Midtown Heights (Preliminary Plat) - 2110 High Street

RE: Preliminary Plat, Midtown Heights

We have reviewed the first (1st) submittal of the preliminary plat for Midtown Heights, and have determined that the following conditions must be satisfied before plat approval can be granted.

MIDTOWN HEIGHTS
PRELIMINARY PLAT

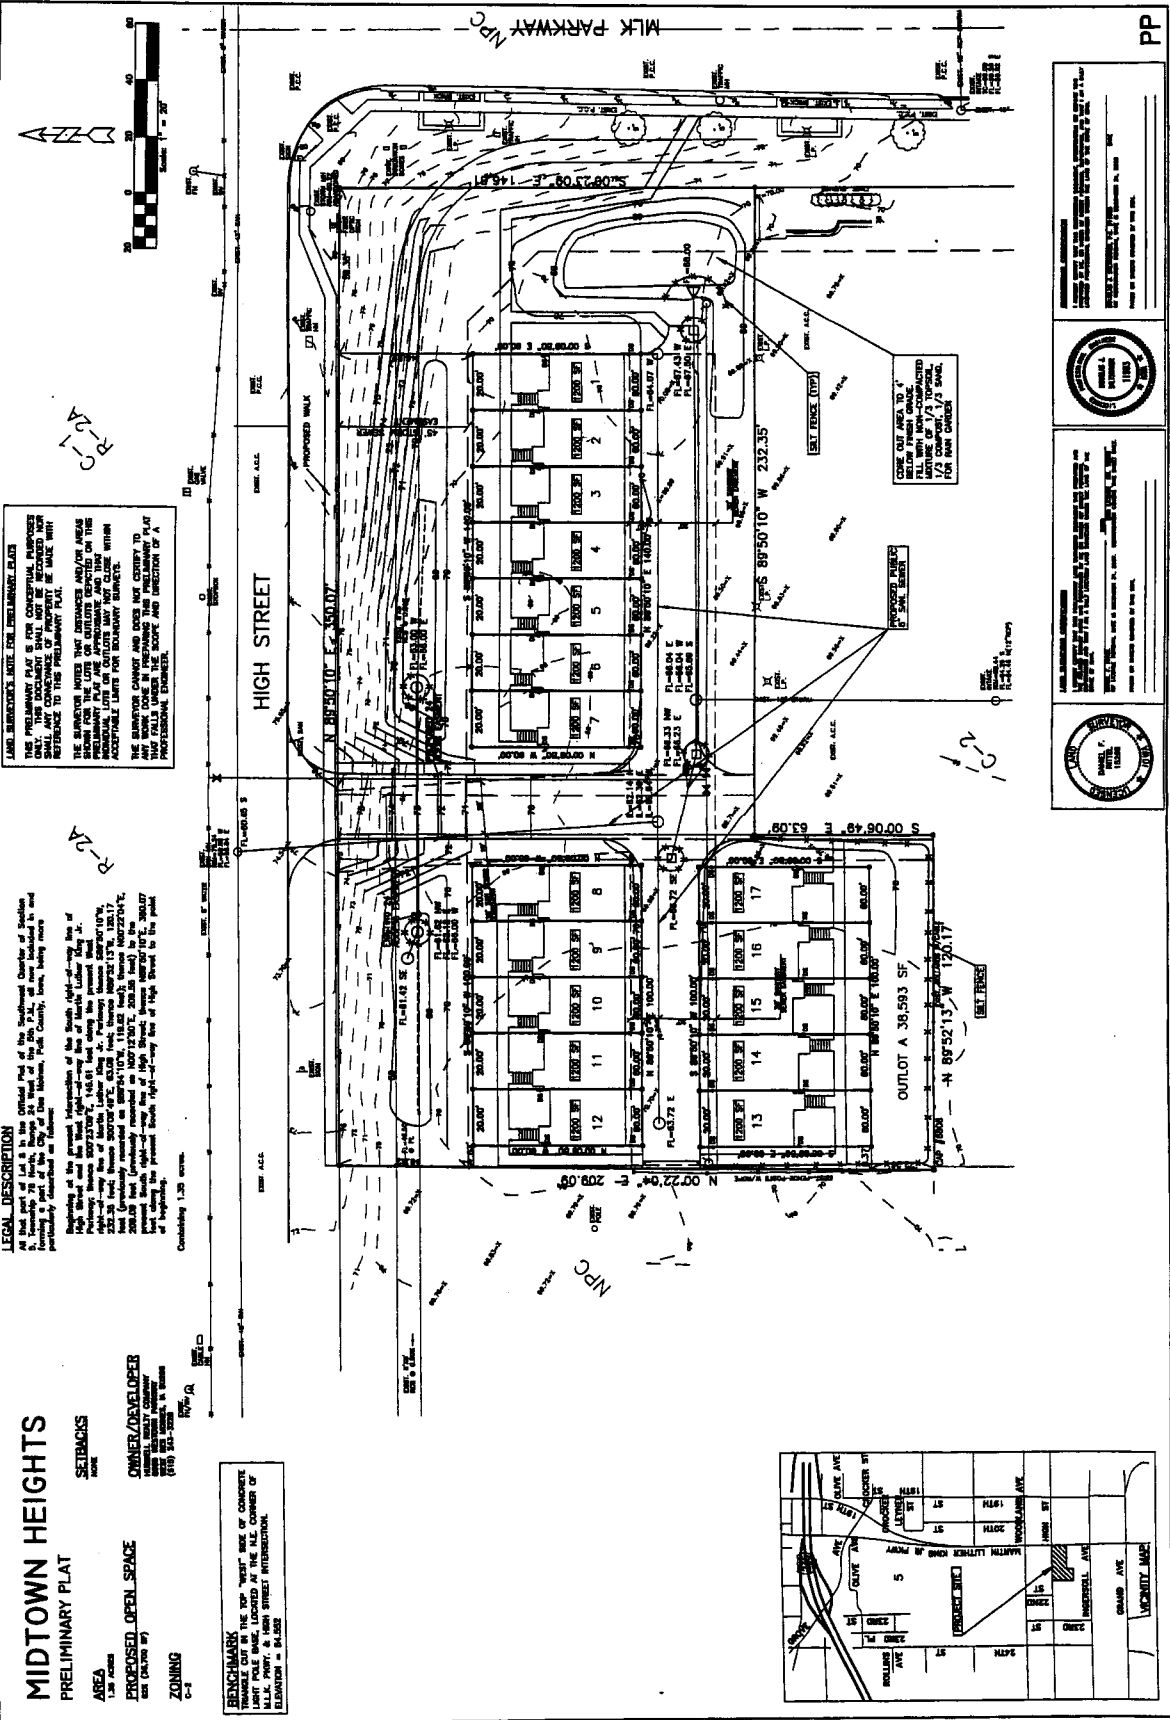
1. Preliminary plats must be certified by an Iowa LLC in addition to an LPE. Certification statements need to be signed and dated.
2. The public sanitary sewer easement shown does not match the approved site plan for the development.
3. Describe the use and ownership of Outlot 'A' on the plat and identify it in more places than one.
4. Generally speaking, the preliminary plat needs to have current information consistent with the approved site plan.
5. The existing 12" storm sewer shown on the southern portion of the lot will need to have a public sewer easement established, if an easement does not already exist. If there is an existing easement over the easement, list the book and page number.

6. The 20 ft. wide private drives shall be marked with permanent NO PARKING- FIRE LANE signs. Signs shall have a minimum dimension of 12 inches wide by 18 inches high and have red letters on a white reflective background. Note this information on the preliminary plat.

- 7. The proprietor name and address shown does not match up with Polk County Assessor's Records (Midtown Heights, L.C.) Please correct on the plat.
- 8. From the Building Department: The proposed property lines at units # 1, 7, 8, 12, 13 & 17 are shown at the edge of the building, which by Code, does not allow for openings such as windows on the outer-most exterior walls. The proposed property line should be moved so that there is a minimum of 5' from the building wall lines on the above units, or a "no-build" easement should be sought for 5' adjacent to the exterior walls, in accordance with Building Ordinance Section 26-212.

- 9. Provide the number of lots in note format on the plat.
- 10. Show addresses and street names on the plat. A listing of assigned lot addresses is enclosed.

- 11. Label the drive accessing the site from High Street as a "private drive."
- 12. General Note: This preliminary plat is slated to appear before the Plan and Zoning Commission on December 6th, 2007.
